RR/2023/1948/P

Springfield
Whatlington Road
Whatlington

Rother District Council

Report to - Planning Committee
Date - 14 December 2023
Report of the - Director – Place and Climate Change
Subject - Application RR/2023/1948/P
Address - Springfield, Whatlington Road, WHATLINGTON
Proposal - Proposed demolition of lawful dwelling approved under RR/2019/738/O and erection of replacement dwelling in new location as an alternative to approved replacement dwelling granted under extant planning permission RR/2021/1937/P.

SITE PLAN

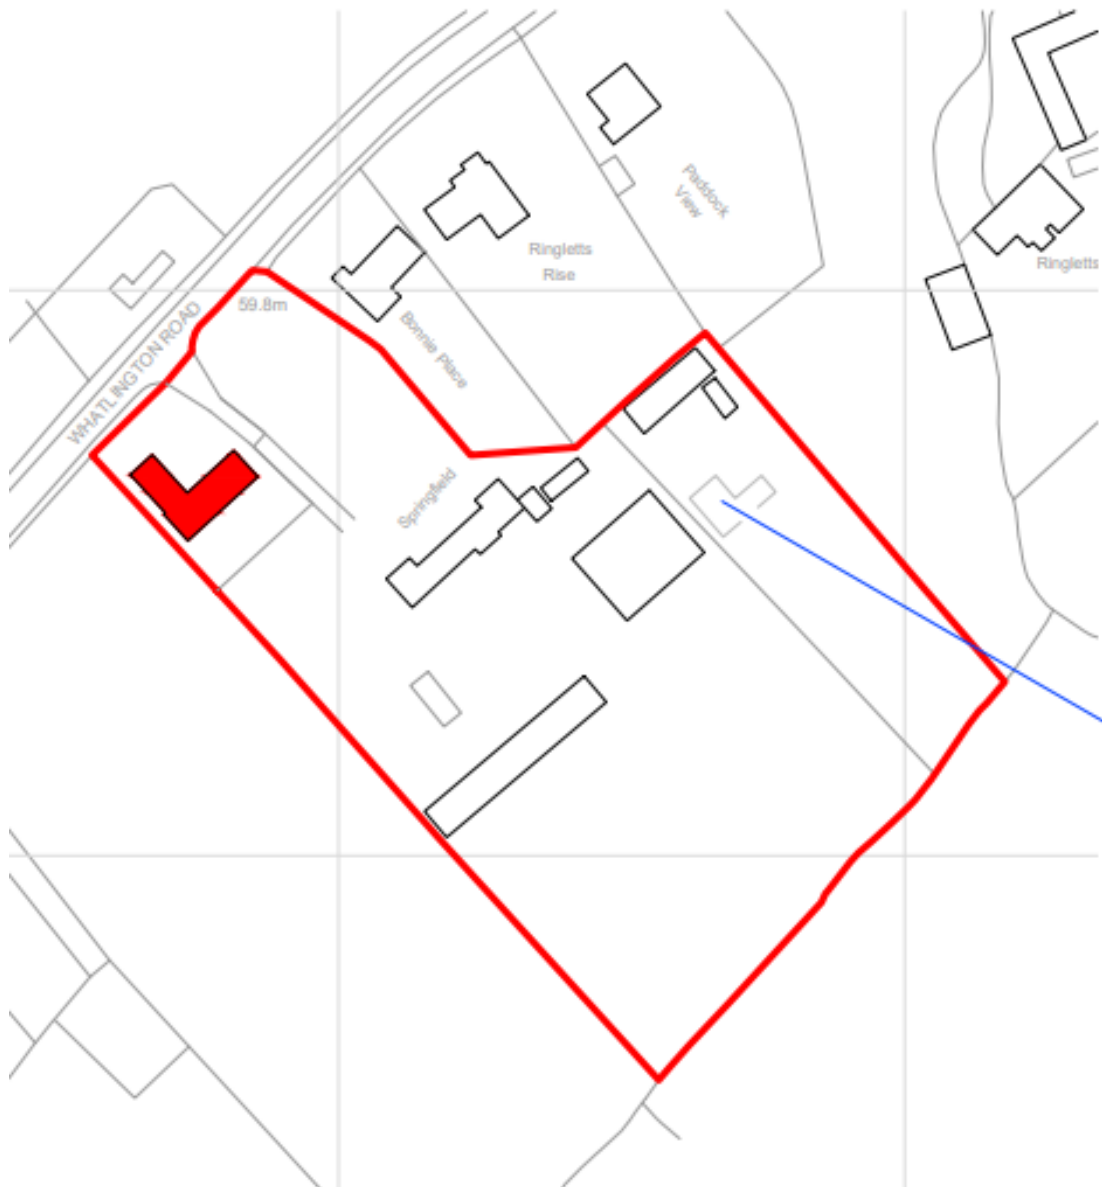
- 2.1 Springfield Nursery is located within the grounds of Springfield in Whatlington, on the north side of Whatlington Road and within the High Weald AONB.
- 2.2 The existing lawful dwelling proposed to be demolished is positioned over 29m to the east of the host dwelling 'Springfield' and set over 20m behind the neighbouring dwelling; Ringlett's Rise. The existing dwelling is positioned well into the site, set back over 88m from the road, which is screened by the neighbouring dwelling. The proposed dwelling is sited 75m west from the position of existing lawful dwelling; set just 10m from the road frontage but behind a tall mature hedge line.
-

- 7.4.12 Nevertheless, the proposed dwelling subject of this application would not be erected over the top of the footprint of the existing dwelling and would be positioned to the northwest of the host dwelling, around 75m away. It would have a much larger footprint than the previously approved dwelling. It would be significantly larger in height and overall mass than the existing dwelling and previously approved dwelling. The sheer increase in size, its location, scale and design would result in the proposed dwelling not having a similar landscape impact as the existing. The proposed dwelling would have a significant adverse impact on the countryside and the landscape and scenic beauty of the AONB.
